Subject: Response to U.S. EPR Design Certification Application RAI No.462, FSAR Ch. 6, Supplement 4

Response to

QUESTIONS for Containment and Ventilation Branch 1 (AP1000/EPR Projects) (SPCV)

Question 06.04-7:

Figure 9.4.1-1—Control Room Air Intake and CREF (Iodine Filtration) Train Subsystem

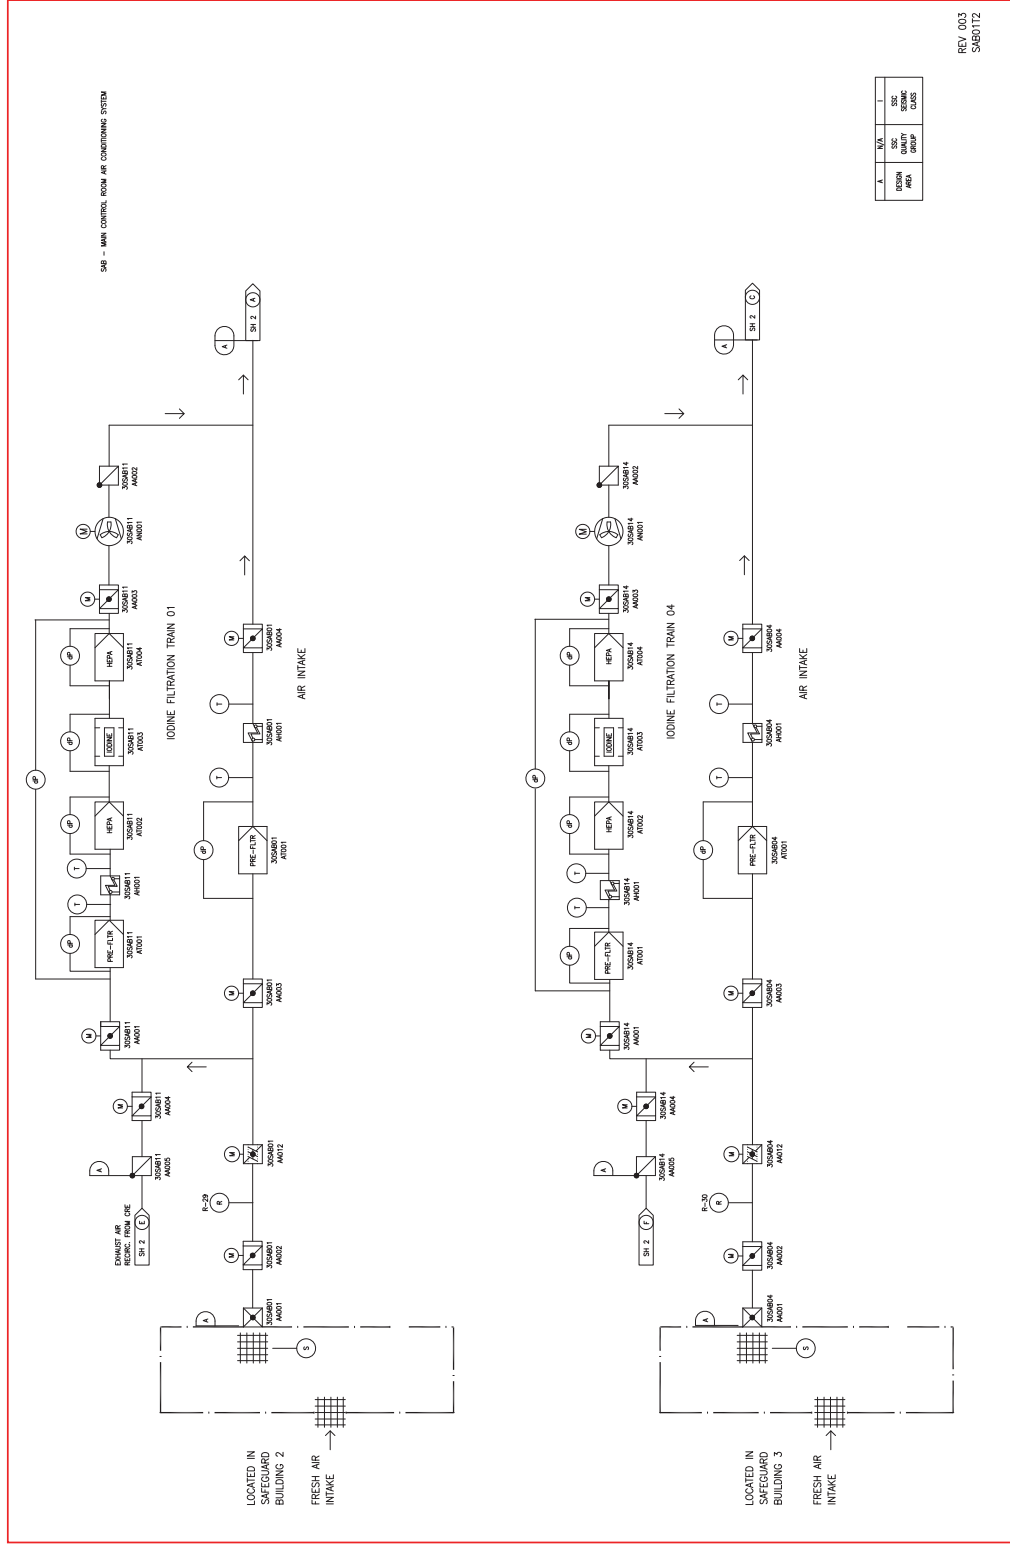
Because toxic gas is site-specific, hardware associated with detection, measurement, and isolation are usually designated the responsibility of the COL and based on the specific toxic gas threat. The EPR design chooses to include some of the design information in the FSAR. Although this approach is not prohibited, addressing all possible toxic gas threat in the FSAR can be a challenge. In Tier 2 Section 6.4.2.4, the revised CRE design was changed to prescribe manual as opposed to automatic isolation of the CRE upon detection of toxic gas. If you choose to address toxic gas in the standard design FSAR, clarification of the following information in the FSAR is needed to make a regulatory finding.

- c. Clarify this change with respect to Tier 1 Table 2.6.1-3 Main Control Room ITAAC number 6.3 which tests automatic isolation of the CRE upon detection of toxic gas from a toxic gas sensor.

The U.S. EPR FSAR has been revised to reflect that a toxic gas event is a site-specific event. The equipment used for the detection, measurement and isolation associated with a toxic gas release are the responsibility of the COL applicant. The specific toxic gas design, which is

currently part of the design of the control room air conditioning system (CRACS) in the U.S. EPR standard design, has been removed from the CRACS, and applicable U.S. EPR FSAR Tier 1 and Tier 2 sections will be revised to reflect this change.

- Figure 9.4.1-1—Control Room Air Intake and CREF (Iodine Filtration) Train Subsystem).

All indicated changes are in response to RAI 462, Question 06.04-7
